**SAN ANTONIO WATER SYSTEM
LEON CREEK WATER RECYCLING CENTER (WRC) INTERCONNECT
TO THE SOUTHWEST BEXAR SEWER PIPELINE (SBSP) PROJECT
SAWS Job No. 10-6501
Solicitation No. B-11-051-MF**

ADDENDUM NO. 3

January 25, 2012

Sheet S-3
52 OF 113

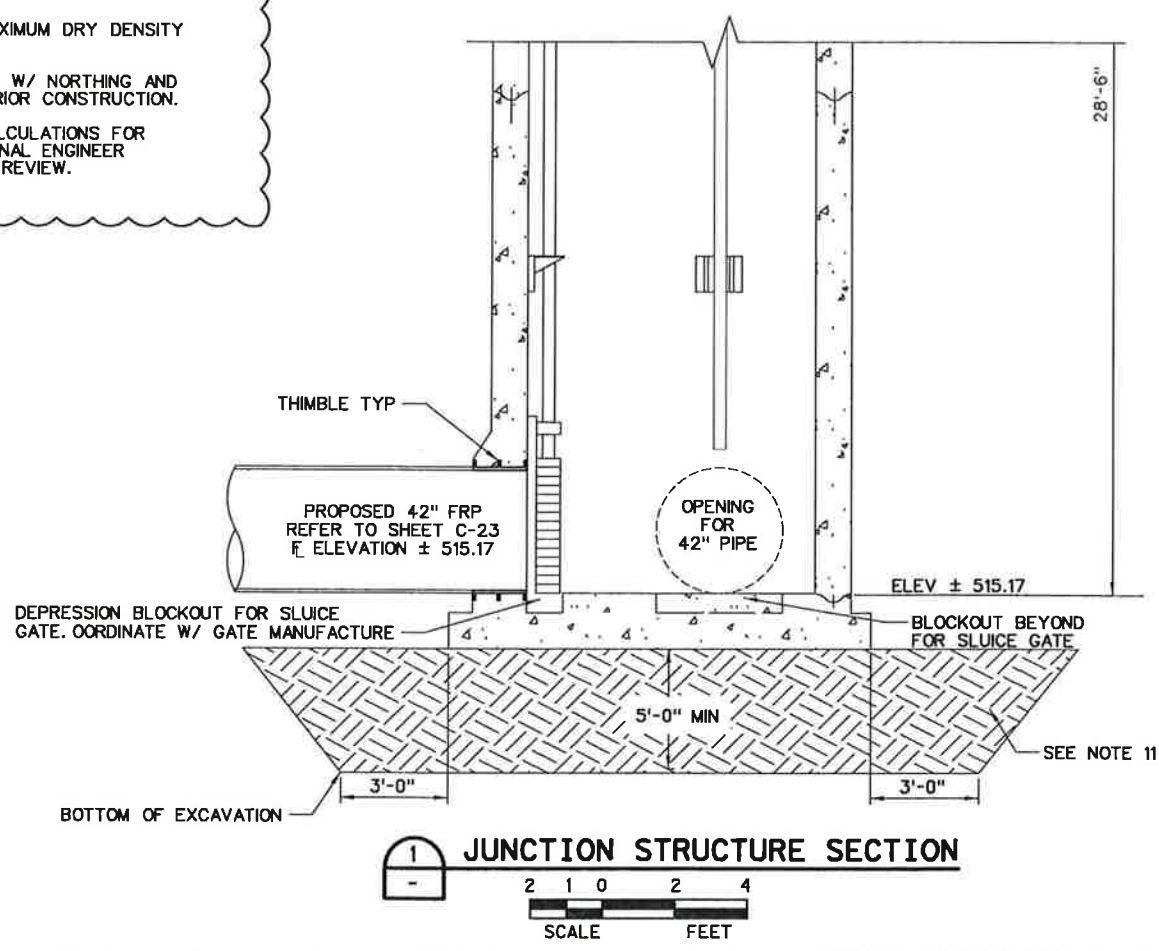
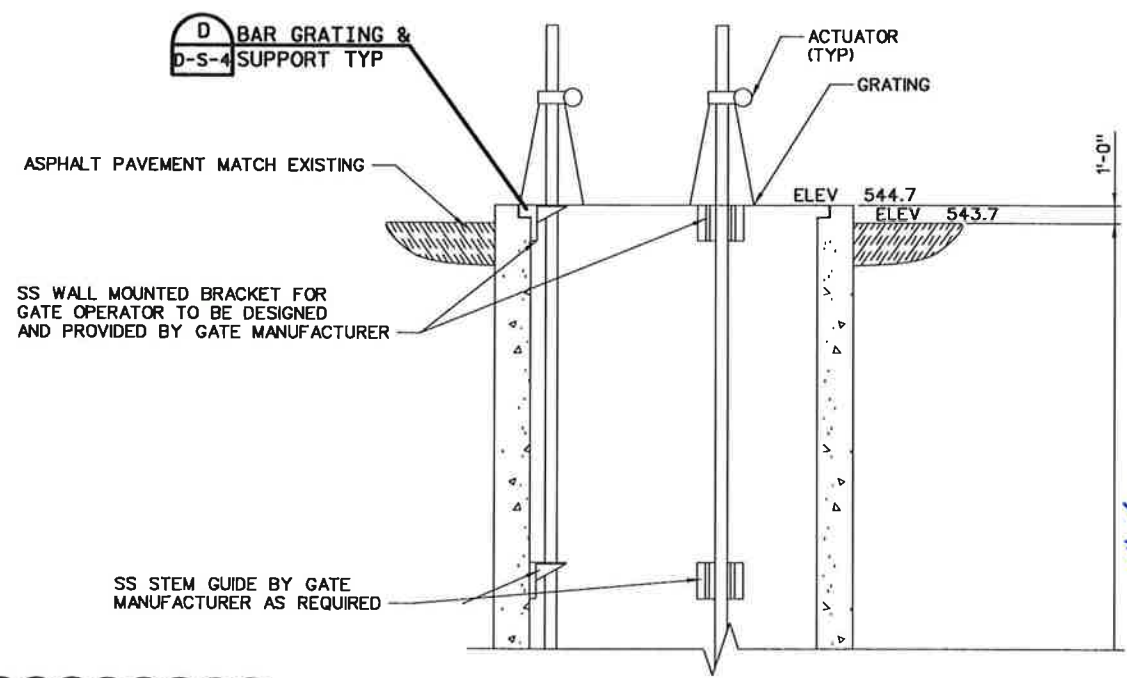
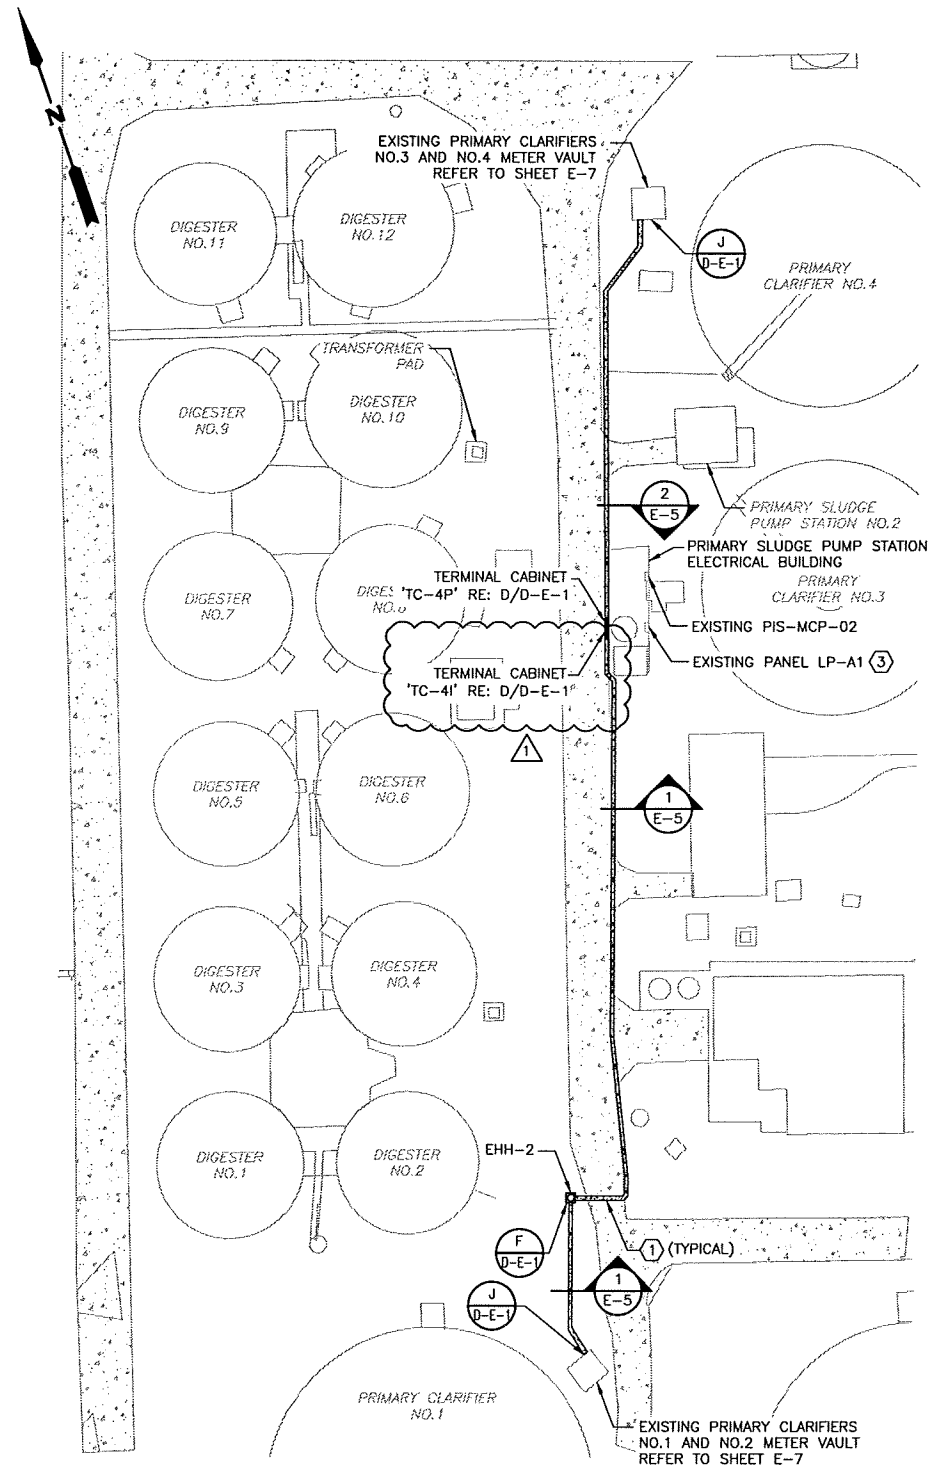
15. Question: Please provide clarification that the proposed junction structure may be made of 8' x 8' pre-cast concrete riser sections? If not, please provide additional details regarding dimensional spacing and steel reinforcement.

Response: Pre-cast concrete riser sections are acceptable for the proposed FEB Drain Line Junction Structure. Please refer to Addendum No. 3, DRAWINGS, Item No. 2 below for additional resolution.

1. DRAWING NO. C-22
 - a. Profile View, replace callout “STA 18+25 BEGIN BORE” with the following:
“STA 18+11 BEGIN BORE”
2. DRAWING NO. S-3
Delete this drawing in its entirety and replace with the attached drawing S-3.
3. DRAWING NO. MD-1 and MD-2, add the following note to these drawings:
“5. EXISTING T-LOCK LINER INSIDE STRUCTURE SHALL REMAIN IN PLACE. SHOULD LINER BE CUT OR DAMAGED DURING CONSTRUCTION, CONTRACTOR SHALL REPAIR IN ACCORDANCE WITH LINER MANUFACTURER’S RECOMMENDATIONS AT NO ADDITIONAL COST TO OWNER.”

SAN ANTONIO WATER SYSTEM
FEB FLOW DIVERSION STRUCTURE PM&ID

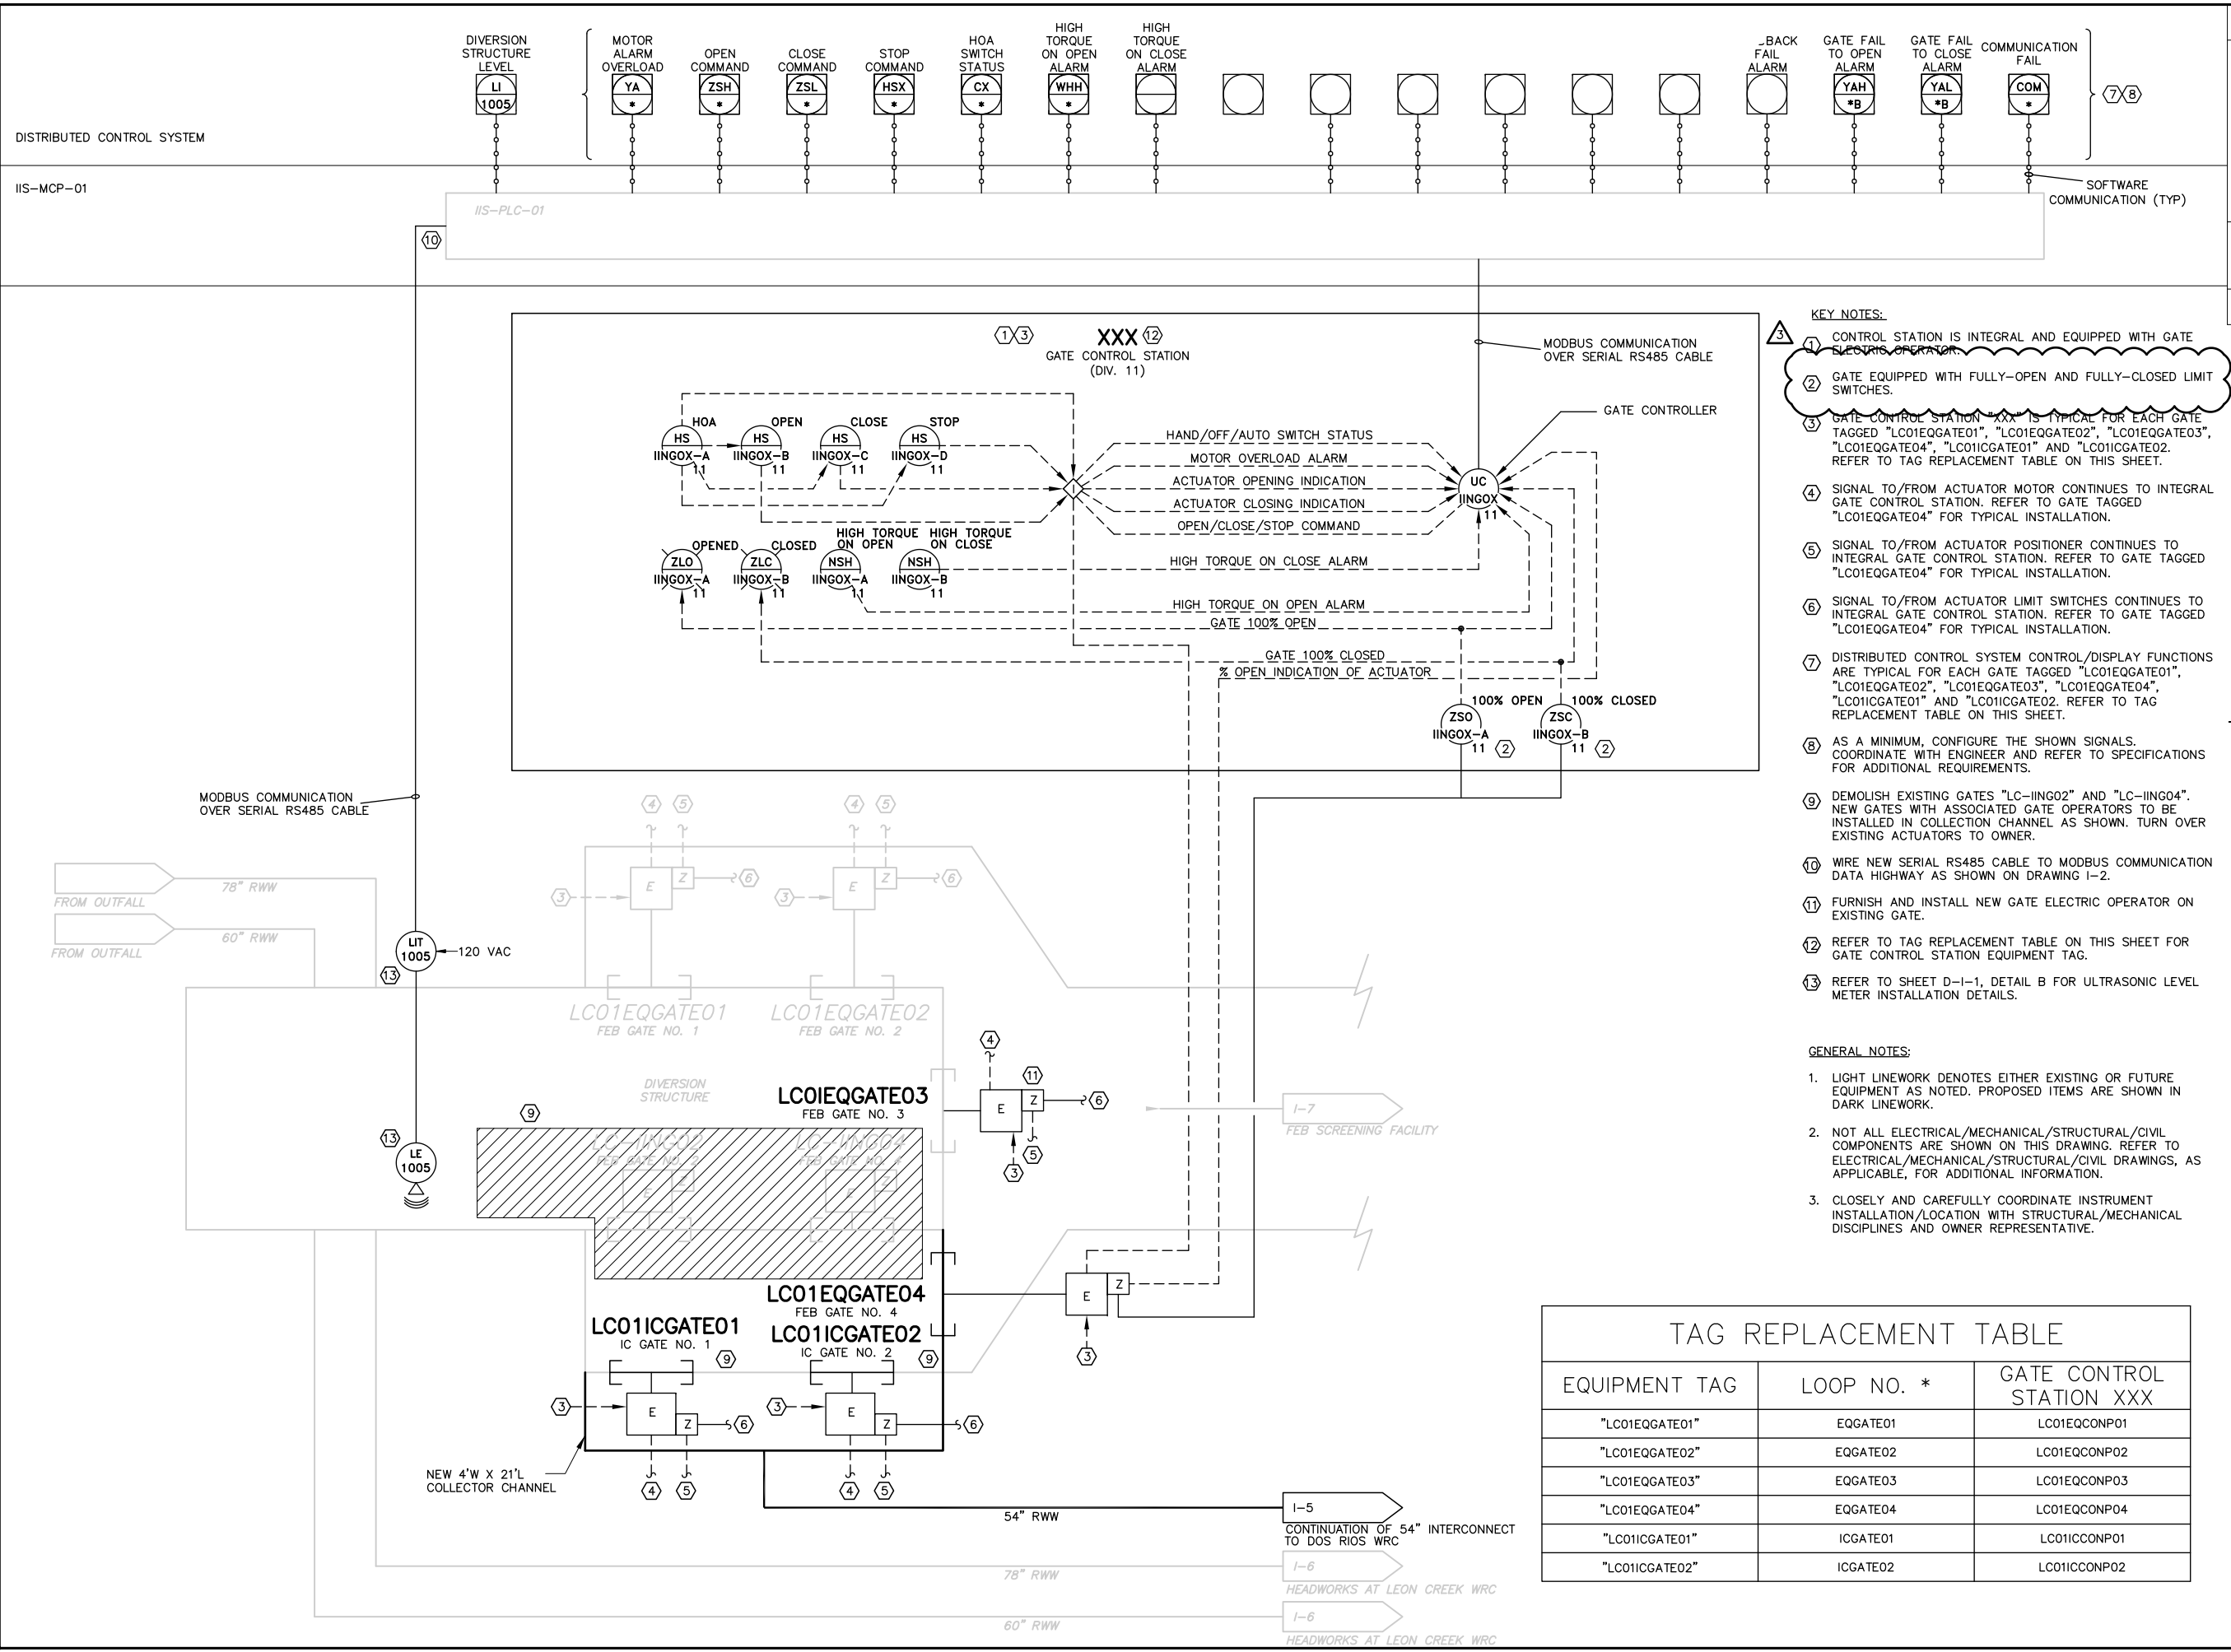
2. Question: On plan sheets I-4 and M-1, the tag number for the 30" x 30" weir/slide gate in the FEB Diversion Structure is "LC01EQGATE04". However, in the slide gate schedule (Spec Section 11280, Page 8), the tag number for the 30" x 30" slide gate in the FEB Diversion Structure is "LC01EQGATE01". Please clarify.

3. Question: Regarding questions 1 and 2 above, there are two gates with the identical tag number "LC01EQGATE01". It is my opinion that the gate in the Drain Line Junction Structure should be "LC01EQGATE06", and the gate in the Diversion Structure should be "LC01EQGATE04".

2. SECTION 11280, Paragraph 2.03 A, correct Junction Structure Tag No. LC01EQGATE01 in the Slide Gate Schedule to “LC01EQGATE06” and Diversion Structure Tag No. LC01EQGATE01 to “LC01EQGATE04”.

Modify drawing as shown on attached drawing I-4.
10. DRAWING NO. I-6

SAWS Job No. 10-6501
LEON CREEK WRC
INTERCONNECT TO THE SBSP
FLOW EQUALIZATION BASINS
AND 60" INTERCONNECT LINE
PM&ID

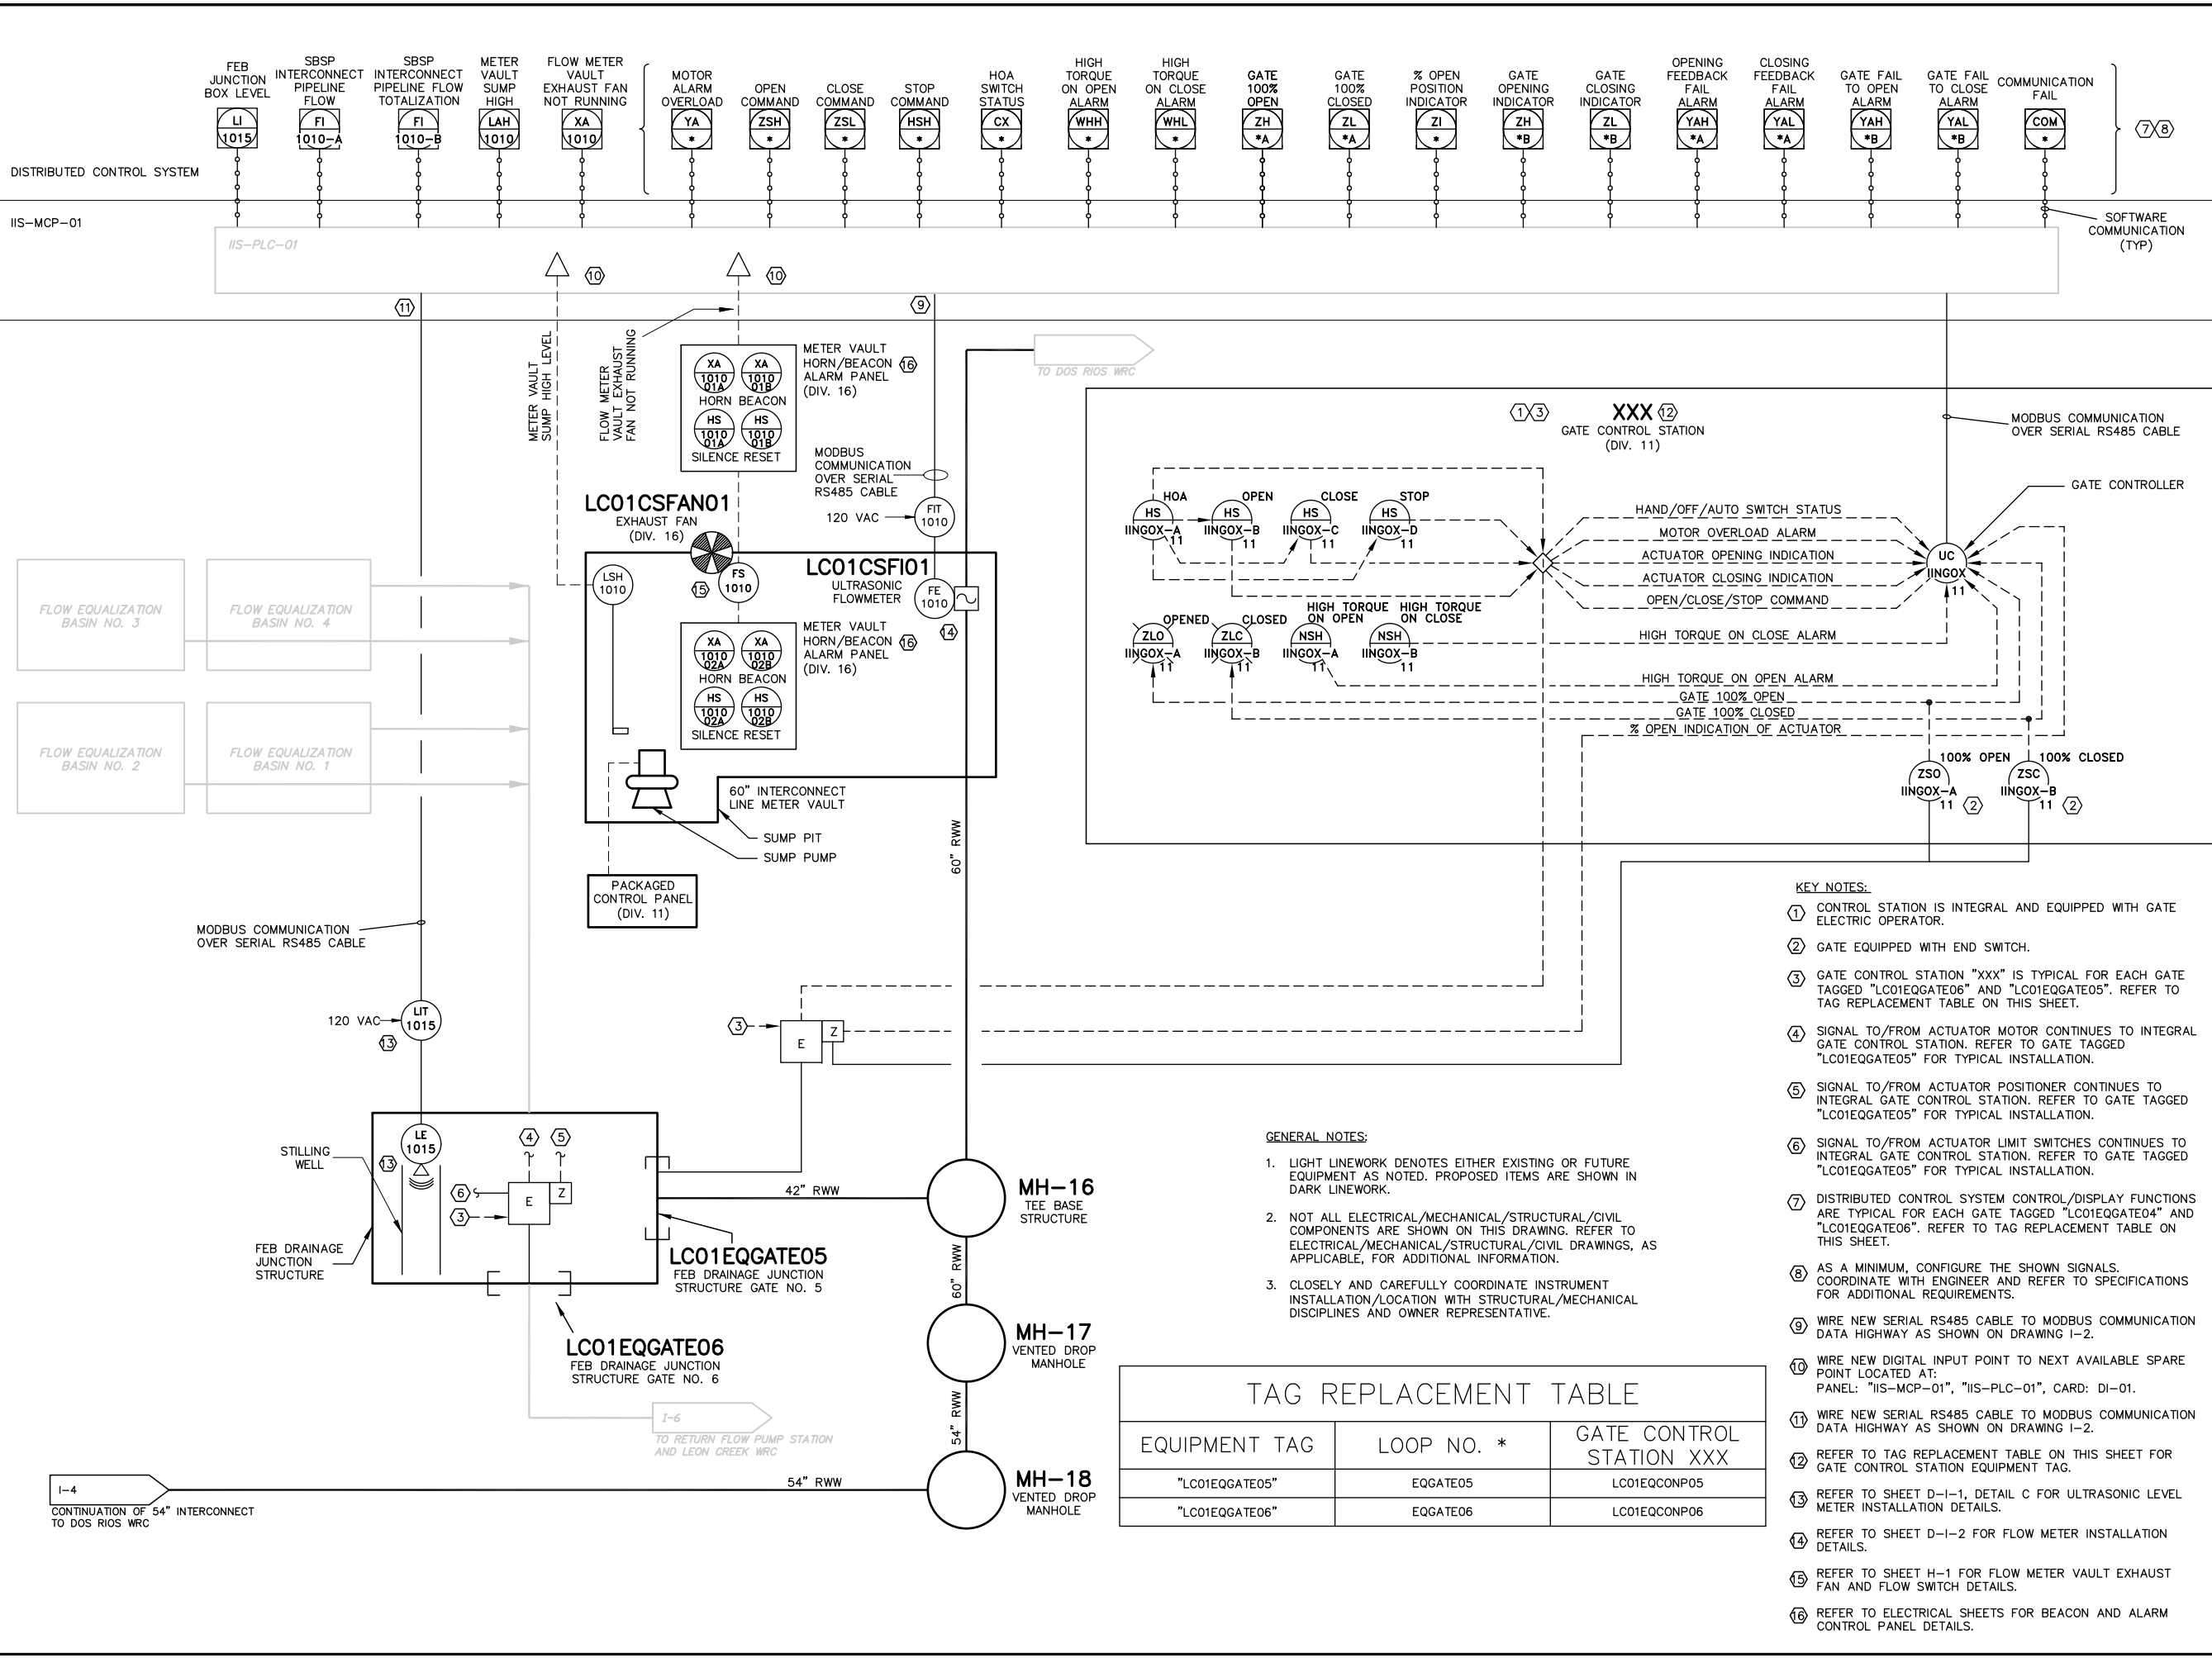
1. Question: On plan sheets I-5 and M-2, the tag numbers for the slide gates in the FEB Drain Line Junction Structure end with "05" and "06". However, in the slide gate schedule (Spec Section 11280, Page 8), the tag numbers for the slide gates in the FEB Drain Line Junction Structure end with "05" and "01". Please clarify.

4. SECTION 11281, Paragraph 2.03 B, correct Junction Structure Tag No. LC01EQGATE01 in the Sluice Gate Schedule to “LC01EQGATE06”.
5. SECTION 15084, replace Paragraphs 1.06 A.1 and 1.06 A.3 in their entirety with the following:
